SERVICE BULLETIN

APPLICABILITY: 2014MY and Later STI Models
SUBJECT: Design Change to Reverse Idler Gear Components

NUMBER: 03-73-14
DATE: 03/10/14

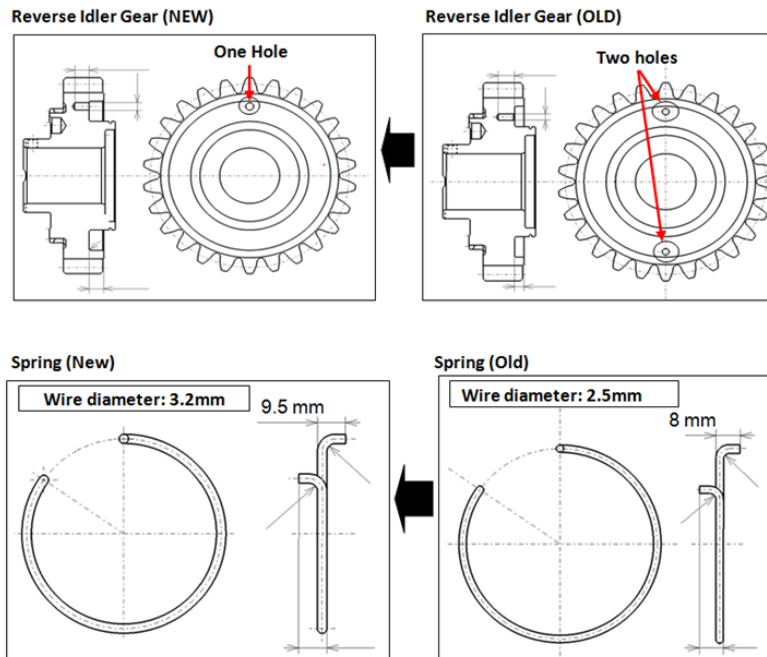
This bulletin informs of a design change to the reverse idler gear and its internal spring along with a revised assembly procedure. The only purpose for the change was to enhance production efficiency.

The new reverse idler components were incorporated into production during mid-October, 2013 starting with VIN E*224413.

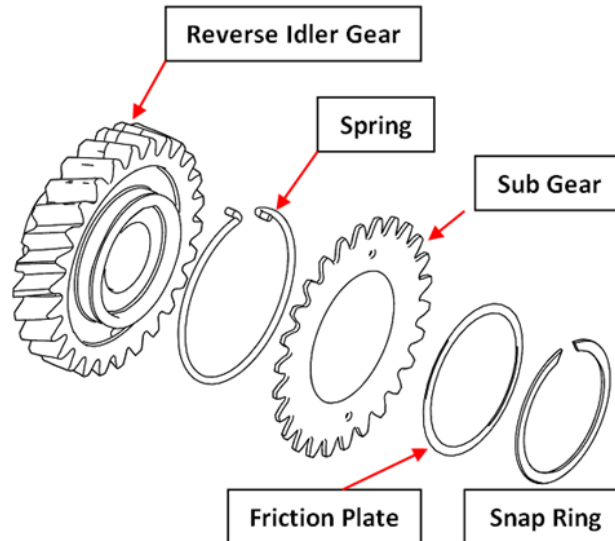
The illustrations below provide a reference for identifying differences between the old and new parts.

IMPORTANT: The revised parts listed in the table below **must always be replaced as a set.**

| PART NAME | NEW PART NUMBER |
|------------------|-----------------|
| GEAR-REV IDLER | 32282AA210 |
| SPRING-REV IDLER | 32369AA040 |
